STATE OF HAWAII
DEPARTMENT OF TRANSPORTATION
HIGHWAYS DIVISION
SITE PLAN
SITE 9 - MP 29.7
EMERGENCY EARTHQUAKE ROCKFALL REPAIRS
VARIOUS LOCATIONS ON HAWAII, UNIT 4
Federal Aid Project No. ER-15(22)
Scale: As Shown Date: December 2009
SHEET No. G-91 OF 7 SHEETS

07/28/10	Added Note per Addendum 3
DATE	REVISION

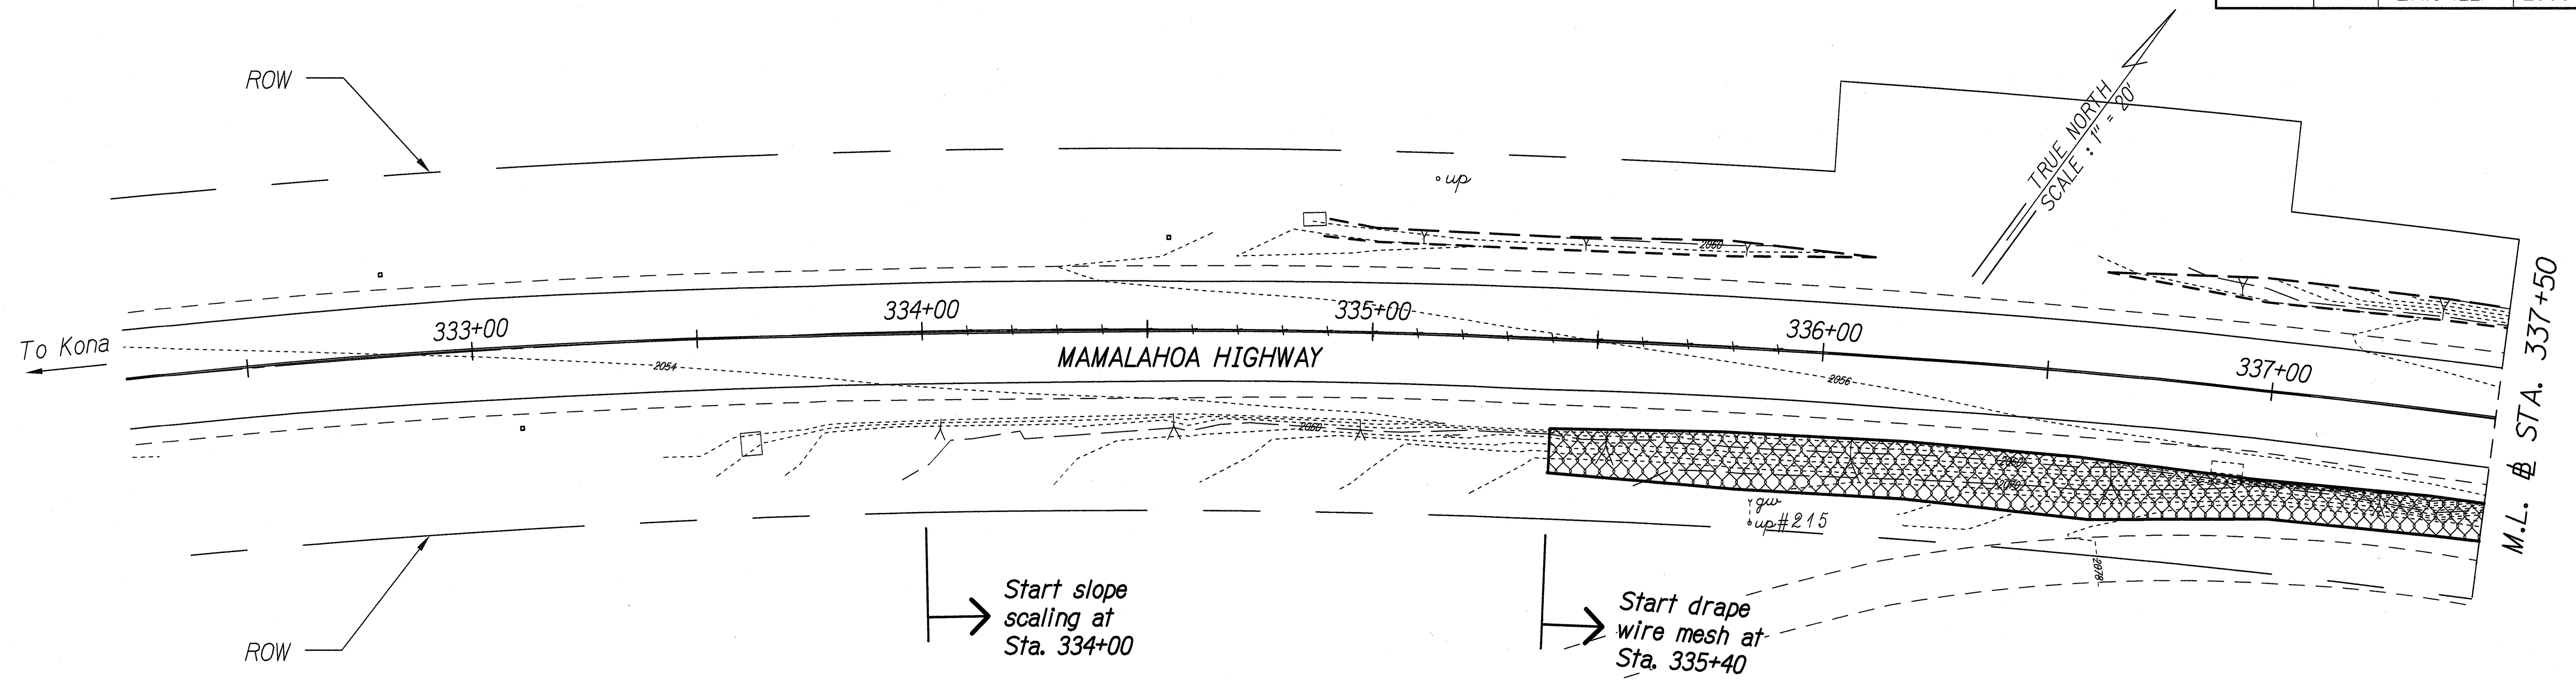
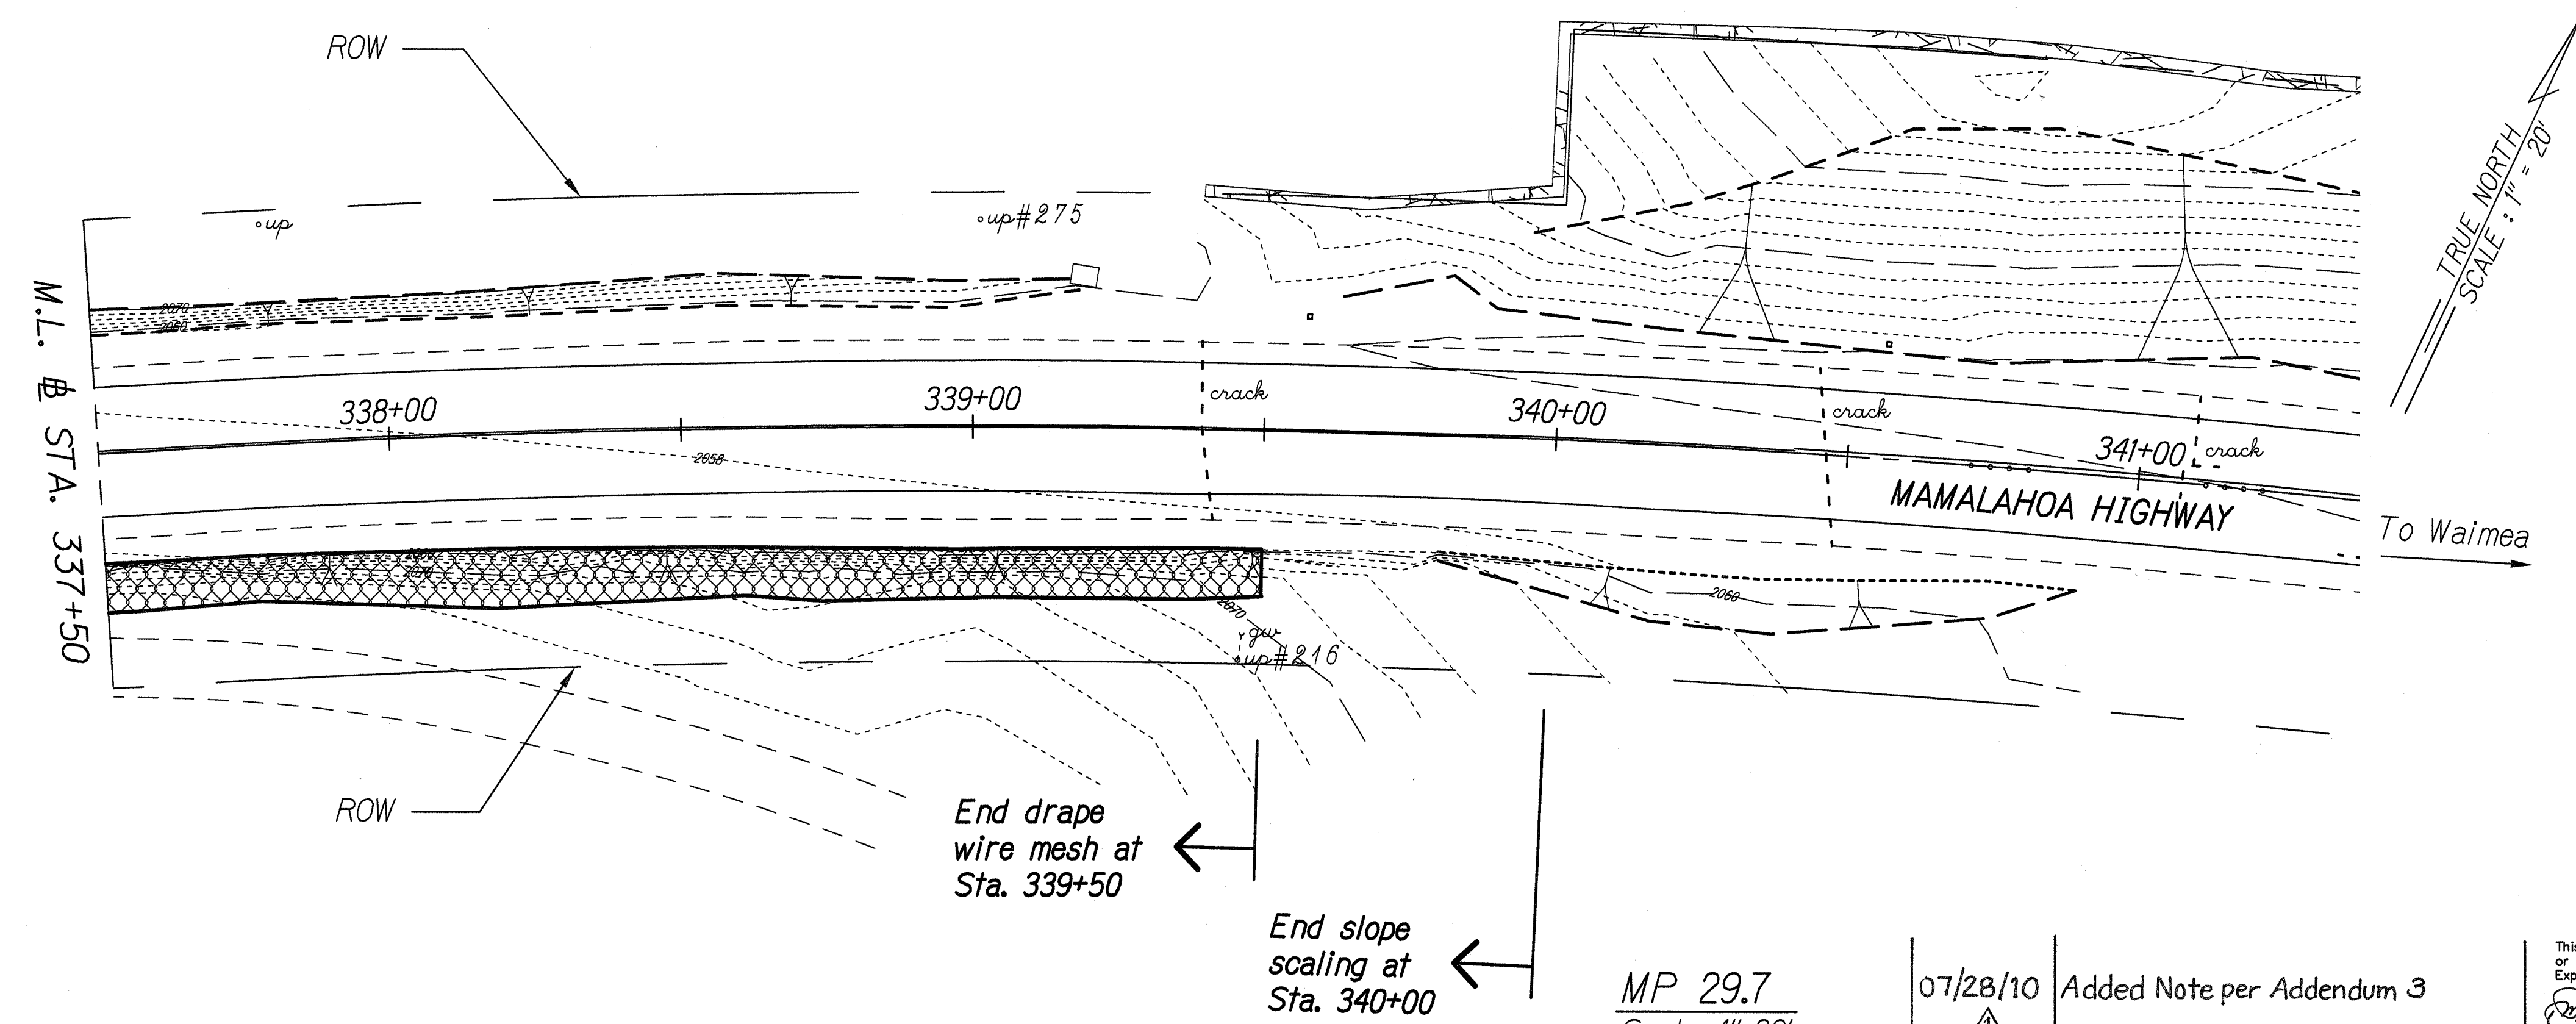
▲ Note: Sta. 333+50 to 340+50 Rt.
Remove and Replace Existing e.p. 4"
White Stripe with Type "C"
Markers at 40' o.c.
